**SOLICITATION AMENDMENT
MODIFICATION DE L'INVITATION**

Title - Sujet CCTV System Upgrade - Beaver Creek CCTV System Upgrade - Beaver Creek Institution	
Solicitation No. - N° de l'invitation 21120-219816/A	Amendment No. - N° modif. 004
Client Reference No. - N° de référence du client 21120-21-3709816	Date 2021-10-28
GETS Reference No. - N° de référence de SEAG PW-\$\$HN-336-80355	
File No. - N° de dossier hn336.21120-219816	CCC No./N° CCC - FMS No./N° VME
Solicitation Closes - L'invitation prend fin at - à 02:00 PM Eastern Standard Time EST on - le 2021-11-12 Heure Normale du l'Est HNE	
F.O.B. - F.A.B. Plant-Usine: <input type="checkbox"/> Destination: <input type="checkbox"/> Other-Autre: <input type="checkbox"/>	
Address Enquiries to: - Adresser toutes questions à: Bisson(hn336), Phillippe	Buyer Id - Id de l'acheteur hn336
Telephone No. - N° de téléphone (613) 295-8641 ()	FAX No. - N° de FAX () -
Destination - of Goods, Services, and Construction: Destination - des biens, services et construction:

SOLICITATION AMENDMENT 004 IS RAISED TO ANSWER THE FOLLOWING QUESTIONS:

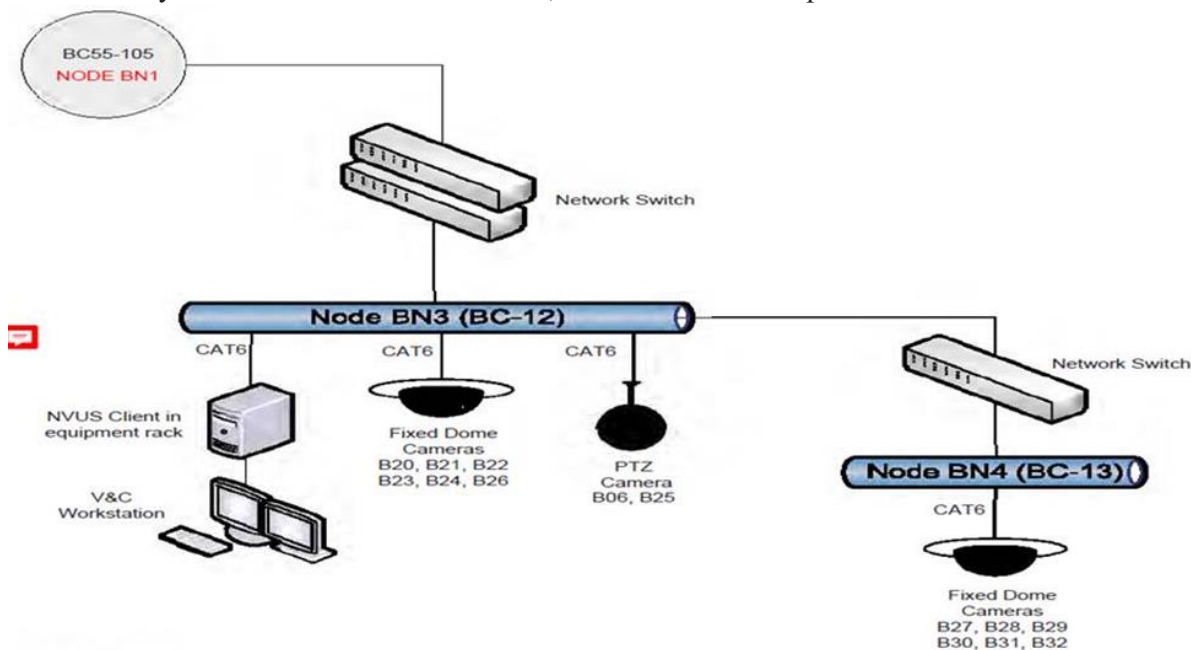
I just caught this conflict of information. The sketch below shows BC13/BN4 being connected to BC12/BN3 but in the document it says this.....

179. Node BN4 (BC13-108) Health Care/SIS Node BN4 will connect to the Node BN1 via a new 12 strand OM3 fibre. The contractor will provide and install a new 12 strand OM3 fibre optic cable between BC13 and BC55, all strands will be terminated and mounted into a new fibre termination bay.

Please clarify where BC13/BN5 connects to, is it BC12 or BC55 please?

Node BN4 connects to Node BN3.
